CHAPTER 3

Comments and Responses

3.1 Comments on the Draft EIR and Responses

This section contains all comment letters and responses to comments. Each comment letter is assigned an alphanumeric code, from A1 through C40, and each comment is numbered in the margin of the comment letter. Responses to the comments follow each letter, and responses are referenced using the same alphanumeric system. For example, the first comment from the first letter, from the National Oceanic and Atmospheric Administration, is designated A1-1, as is the response to it. Testimony from the public hearing is assigned the code “PH” and follows the comment letters.

Figure 3-15a
 Water Surface Elevation Change With Project
 100 - Year Flood Event: Fairfax Area

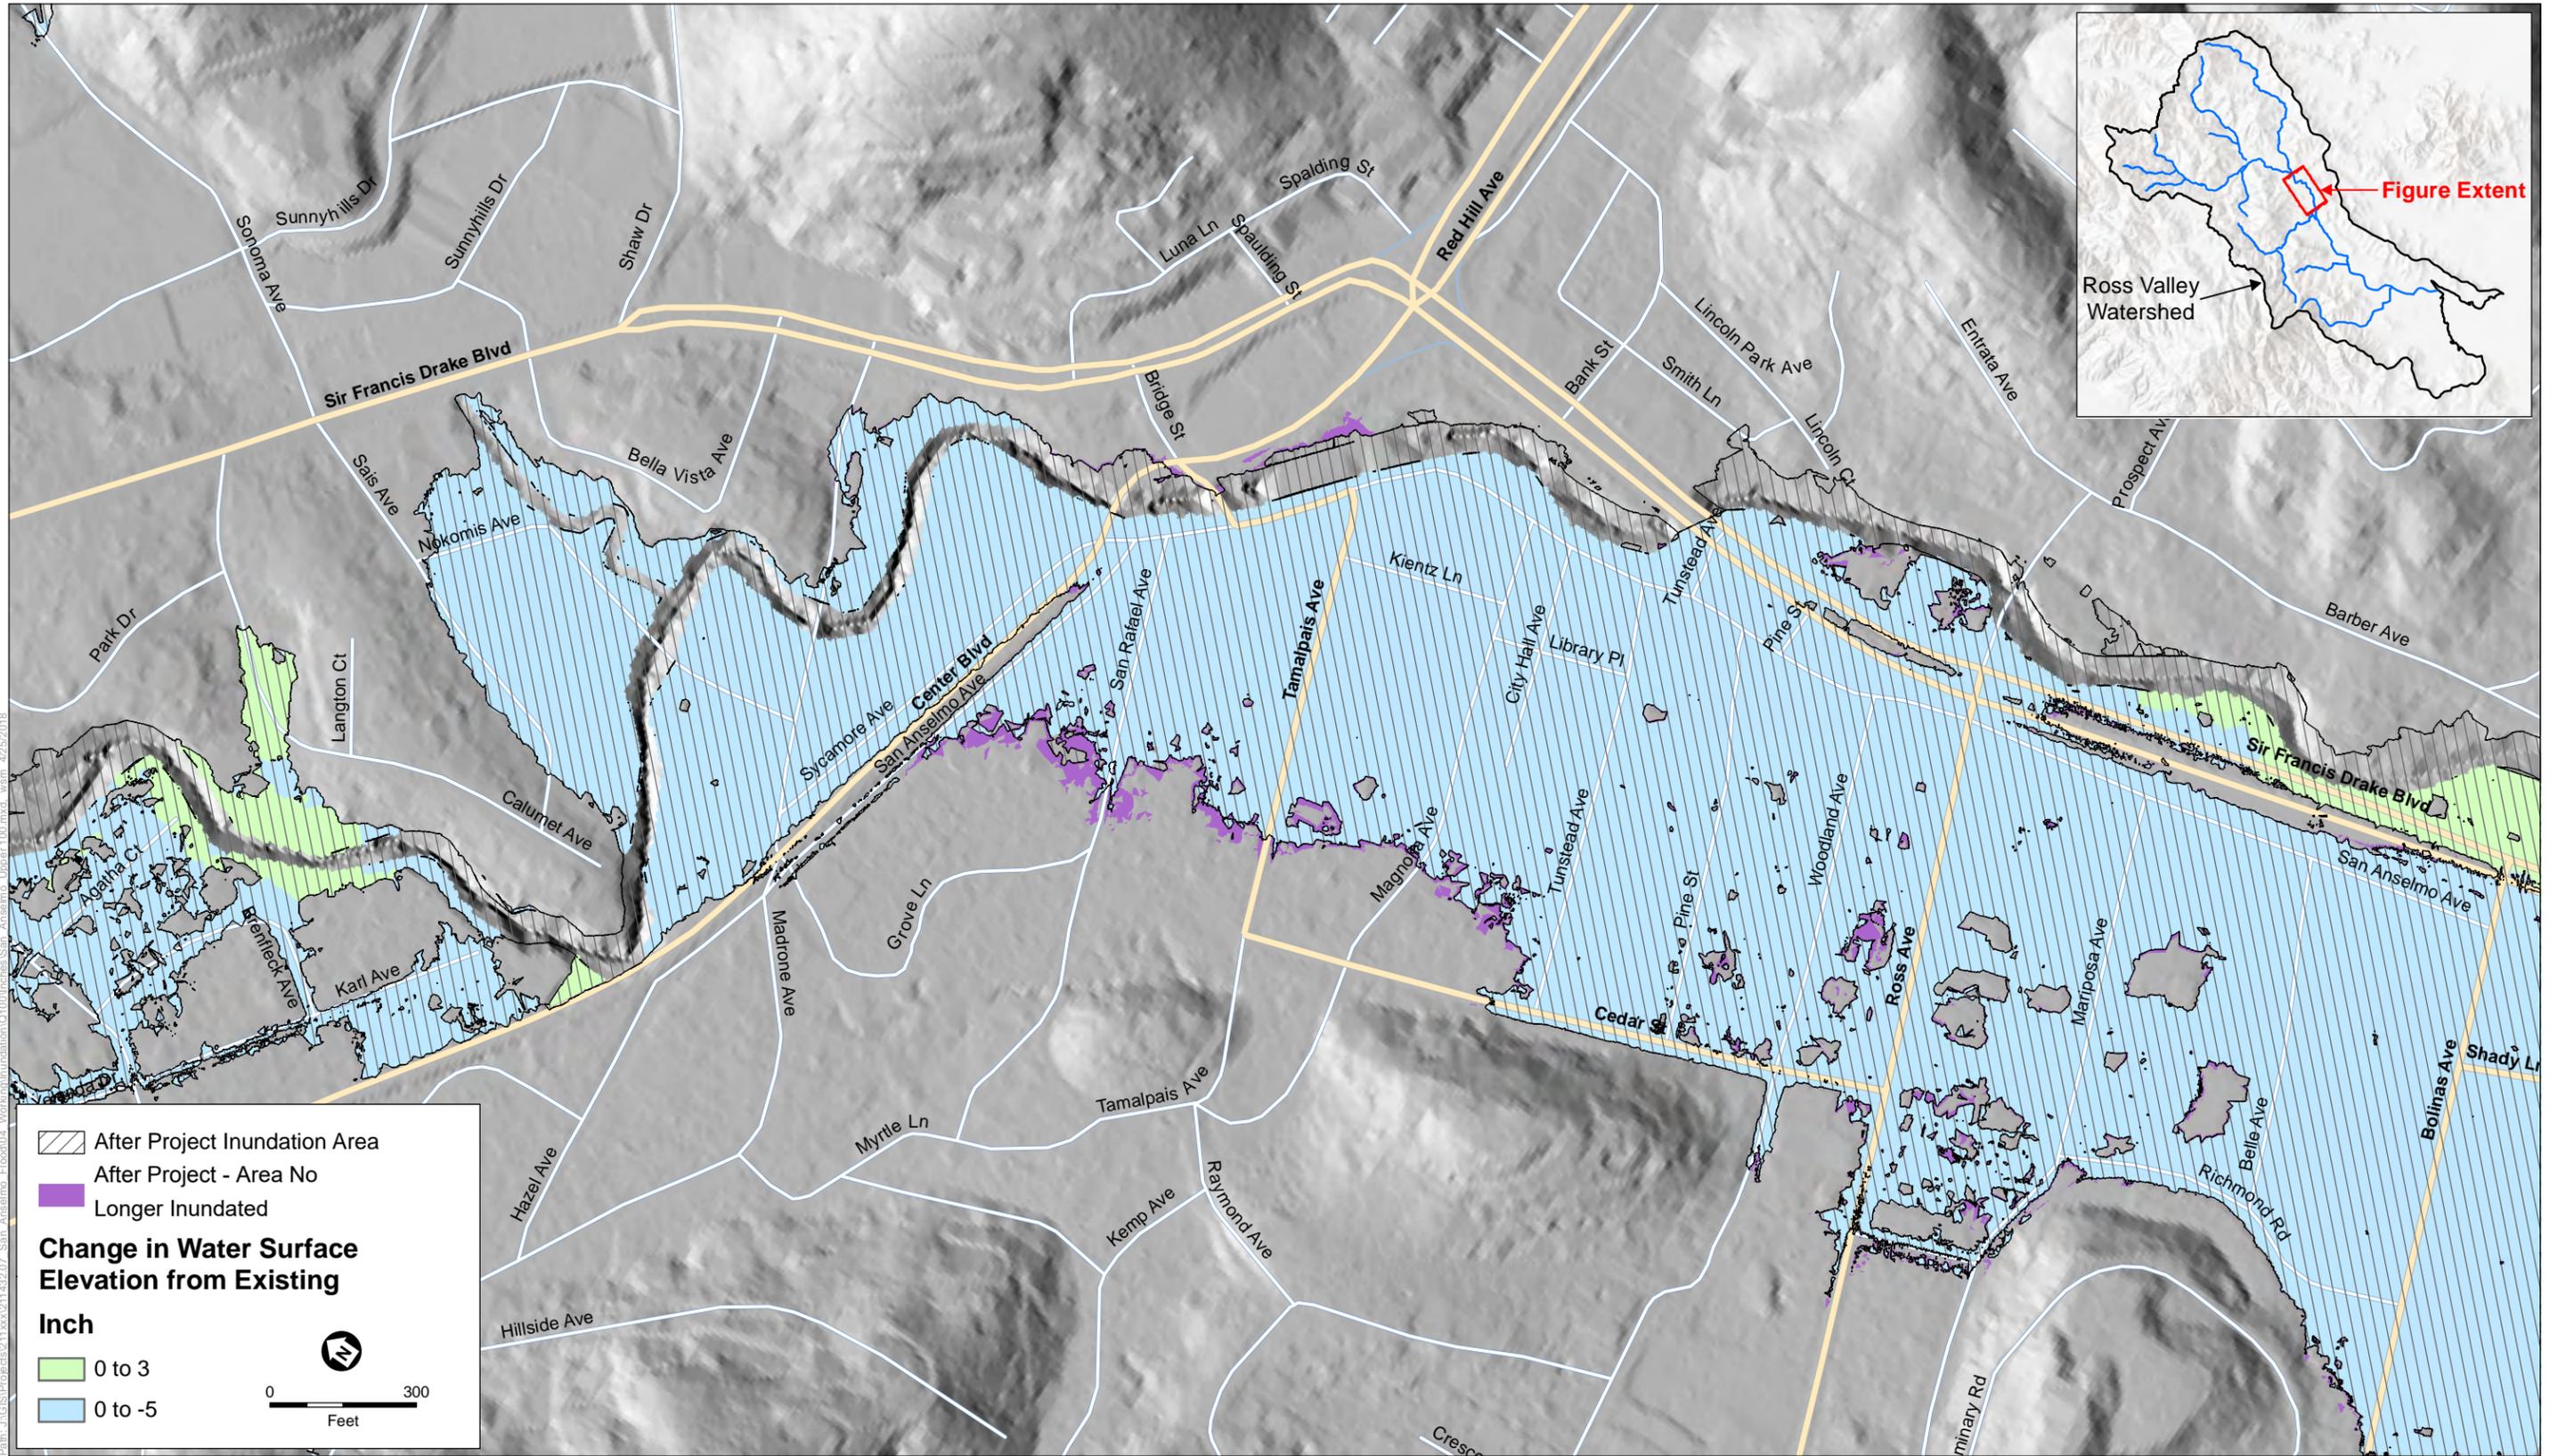
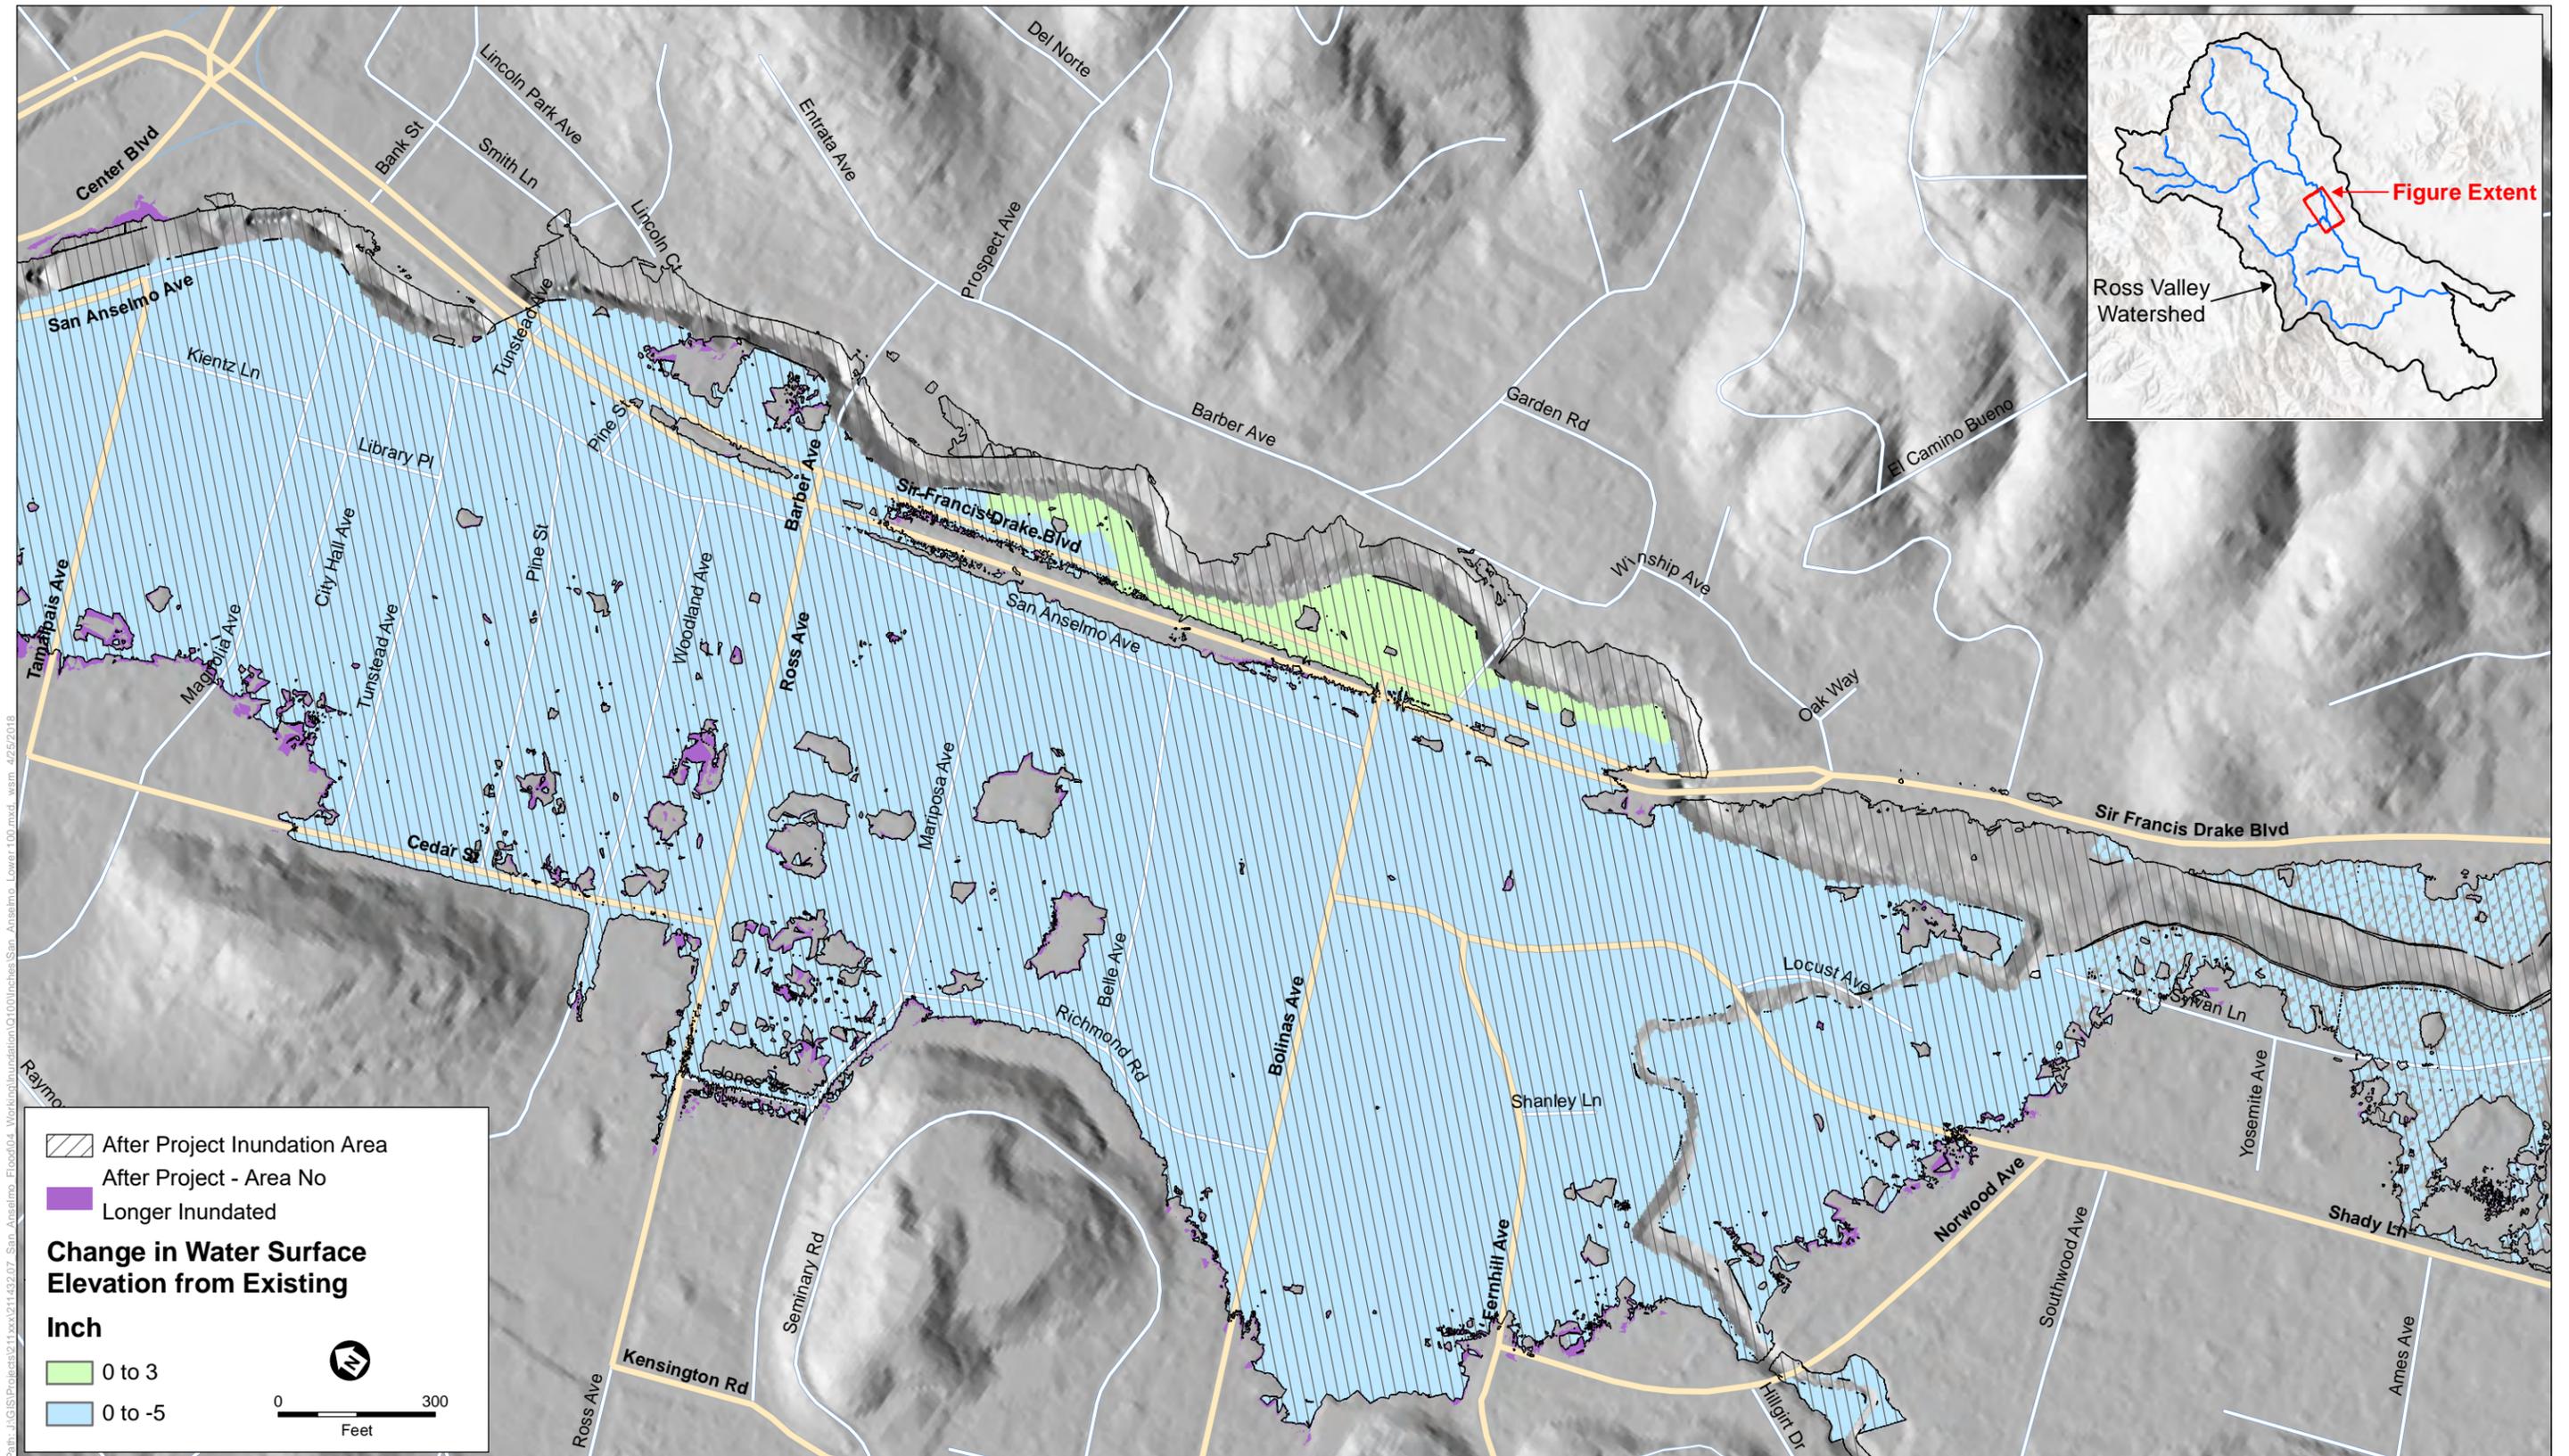
Figures in Chapter 3 (figures 3-13, 3-14, and 3-15), that show water surface elevation, change with project are not easy to interpret. It appears that the purple areas, labeled "After Project Inundation Reduction Area" would be removed from flooded areas during the specified events. However, use of the word "reduction" suggests that they would still be inundated, just to a lesser extent.

Draft EIR Figures 3-13a-c, 3-14a-c, and 3-15a-c have been revised in response to this comment. The revisions to these figures do not result in any changes to the environmental analysis in the Draft EIR.

In response to Comments B1-5 and PH-2, the legend descriptions associated with purple areas of Draft EIR Figures 3-13a-c, 3-14a-c, and 3-15a-c (Draft EIR pages 3-25 through 3-33) have been revised to read:

After Project ~~Inundation Reduction Area~~ – Area No Longer Inundated
